NOTICE OF PROPOSED DEVELOPMENT

SITE:**45 SPOONBILL LOOP, SORELL****PROPOSED DEVELOPMENT:****THREE MULTIPLE DWELLINGS**

APPLICATION NO: 5.2026-137.1
DATE: 28 August 2026

PLANNING APPLICATION - 5.2026-137.1 THREE MULTIPLE DWELLINGS AT 45 SPOONBILL LOOP, SORELL

Figure 1. 100m Density Assessment Area (red line) with 45 Spoonbill Loop (Blue line), highest density (orange), and lowest density (green) (Source: LISTmap 13/8/2026 - annotated)

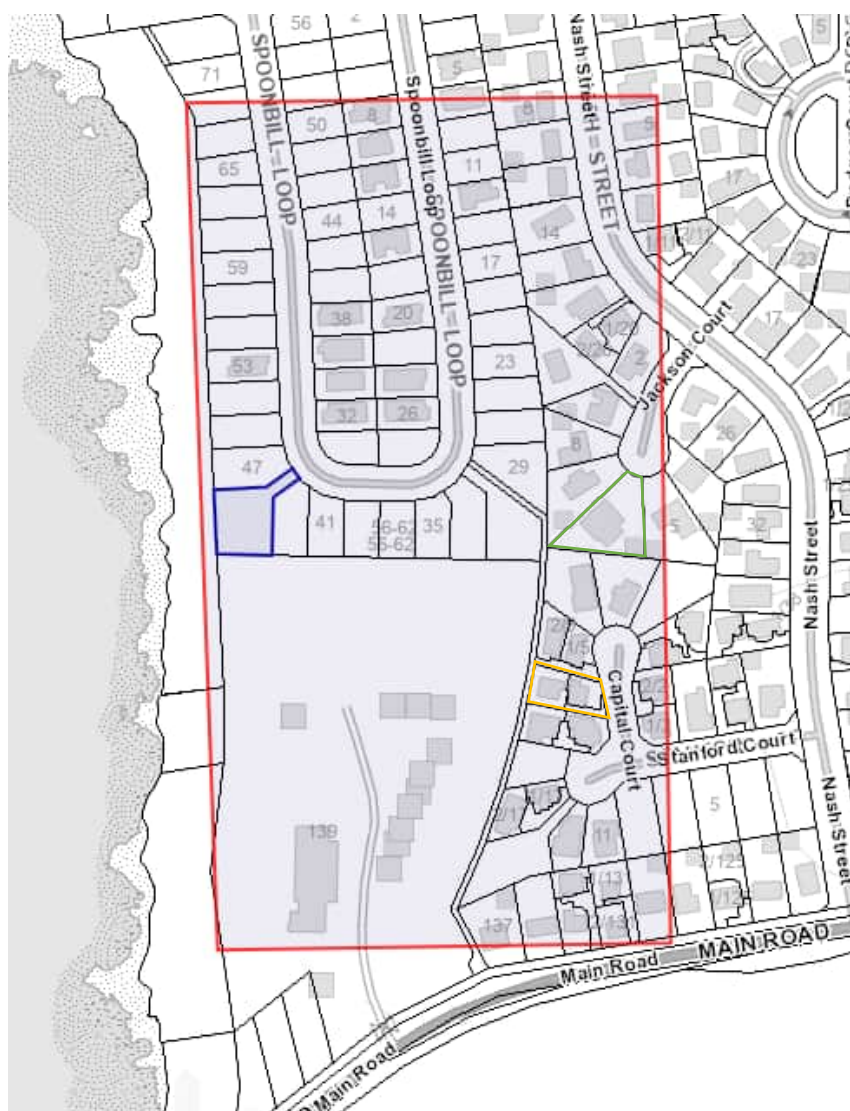
To assess the density of the surrounding area for all forms of development the site area for each address within the red outline in Figure 1, was acquired from PlanBuild on 13/8/2026 (representing approximately 100m from 45 Spoonbill Loop). Site areas for strata sites was determined using the measuring tool in LISTmap. Site areas for a number of addresses in Spoonbill Loop (See Table 2) were not available on PlanBuild so these addresses have been excluded from the assessment. Within the area bounded in red (refer to Figure 1), the site area per dwelling ranges between a minimum of 342.5m² (3 Capital Court), to a maximum of 1,209m² (7 Jackson Court) -refer to Table 2. Excluding these two outliers, the density range is between 356m² and 1170m². With a site area per dwelling of 320m², the proposed density falls outside this range.

Figure 2. Density Assessment surrounding area (red line), highest density (orange) and lowest density (green) (Source: LISTmap 13/8/2026 - annotated)

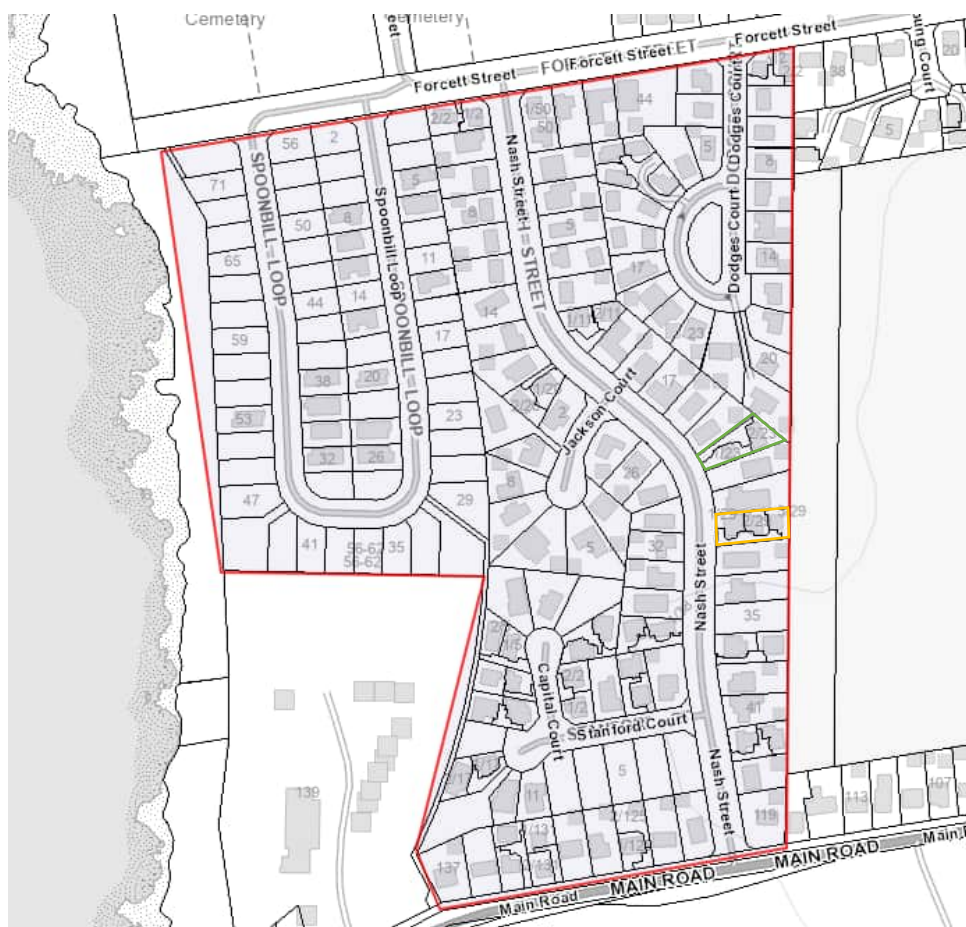
The second test is the site area for multiple dwellings developments within the surrounding area. This area is subjective, but in our assessment, it is reasonable to define this by bordering the Sorell Schools (43 Gordon Street) to the east, Forcett Street to the north, the Orielton Lagoon foreshore reserve to the west and Main Road to the south. This area is shown in the red outline shown in Figure 2. The density assessment for unit sites in this area is shown in Table 2. The minimum site area per dwelling for units within the broader area was 305m² (29 Nash Street), with a maximum of 435m² (4 Capital Court). Again excluding these outliers, the range is between 307m² (2 Dodges Court) and 408m² (133 Main Street). With a site area per dwelling of 320m², the proposed density falls inside this range.

Looking at these two assessments, whilst the proposed density is not within the general density range within 100m, there are 21 multiple dwellings dispersed though the surrounding area. The range of densities is broad within the surrounding area and the proposal's density is broadly within the range of densities in the surrounding area, albeit at the higher end of the range. Dispersed higher densities is consistent with general town planning principles and is reflected in the objectives of the General Residential Zone, particularly clause 8.1.1.

On this basis, the proposed density is compatible with the density of existing development on established properties in the area and thus consistent with 8.4.1 P1(a) in our view.
